GROUP	MODEL
	TRA	2023MY Niro P/HEV (SG2 P/HEV)
	NUMBER	DATE
	106	February 2023

TECHNICAL SERVICE BULLETIN

**SUBJECT: 6-SPEED DCT JUDGEMENT LOGIC IMPROVEMENT /
GROUND BOLT TIGHTENING (P074A73)**

This bulletin provides information to tighten both the clutch actuator and transmission control unit (TCU) grounding bolts then, upgrade the software logic of the 6-speed dual clutch transmission (DCT) on some 2023MY Niro P/HEV vehicles produced from June 14, 2022 through December 12, 2022, which may exhibit a poor shift quality concern and MIL 'ON' with DTC P074A73 stored. Follow the procedure outlined in this publication to tighten both the clutch actuator and TCU grounds, then upgrade the software logic of the 'A/T' system using the KDS ECU Upgrade function as described in this bulletin. For confirmation that the latest reflash has been applied to a vehicle you are working on, verify the ROM ID using the table on pages 4 and 5 of this bulletin.

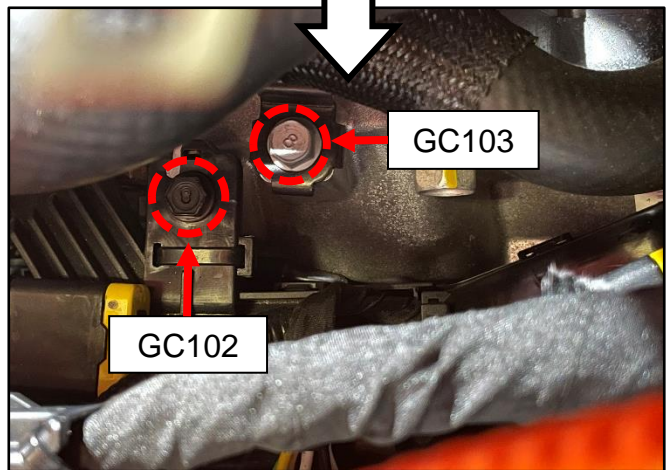
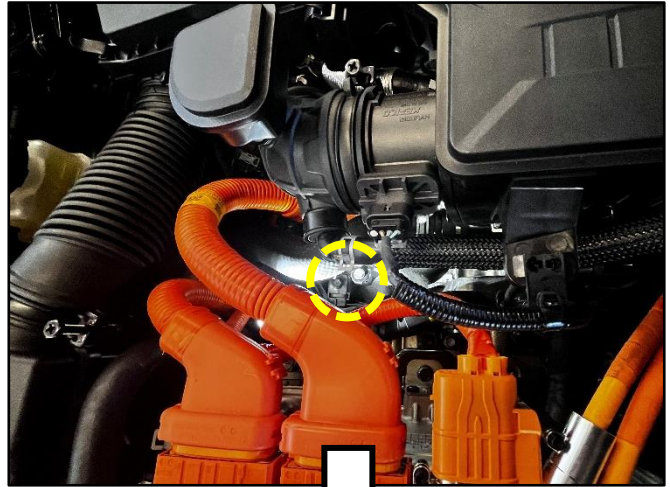
1. Using a 10mm socket with an extension, tighten the clutch actuator ground bolt (GC103) and TCU ground bolt (GC102).

Tightening torque for GC102:
5.8 - 7.2 lb.ft (7.8 - 9.8 N.m)

Tightening torque for GC103:
7.2 - 8.7 lb.ft (9.8 - 11.8 N.m)
